## DRAWING AMENDMENTS

Fig 21

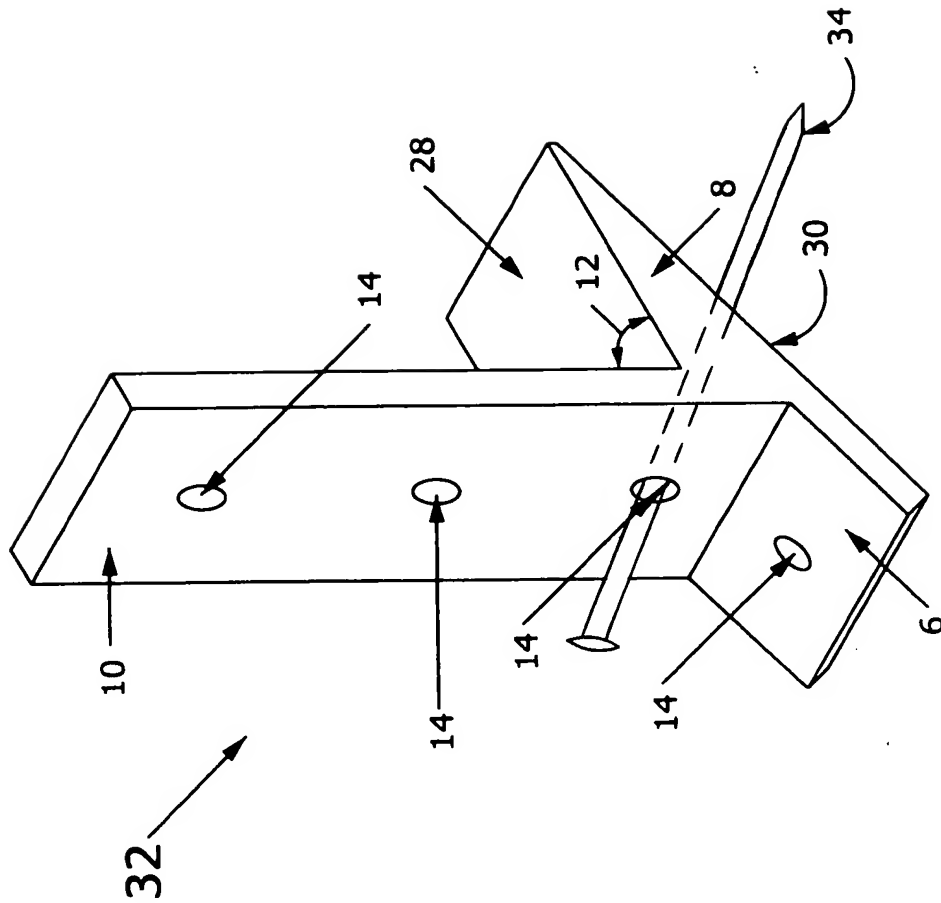
applicants believe that no new matter has been added thereby since page 17, lines 6-10 of the original disclosure discuss a molded embodiment. The applicants argue that the Examiner should allow this 'new' Fig. 21 to be a part of their allowed disclosure, as it is the finished shape of their valley truss strap and the manner in which it is used that are novel, irrespective of the method used to create that shape. Further, 'new' Fig. 21 is consistent with the elected Group 4 wherein the base member does not extend beyond the tapered end of the wedge. Other U.S. Patents, such as U.S. Patent 4,455,791 to Elko (1984), which in the discussion of its Fig. 4 discloses that its gutter's cover can be preformed out of plastic or metal, as well as U.S. Patent 6,516,498 to La Coy (2003) for a clamp that discloses manufacture out of plastic or metal, support the applicant's argument that different materials, to include plastics and flat steel, can be contemplated as alternative options for the construction of the embodiments in a single patentable invention. Therefore, the applicants respectfully argue that the Examiner herein should follow precedent and allow proposed 'new' Fig. 21 to become a part of the instant patent application disclosure. Thus, the applicants request reconsideration and clarification by the Examiner on this issue.
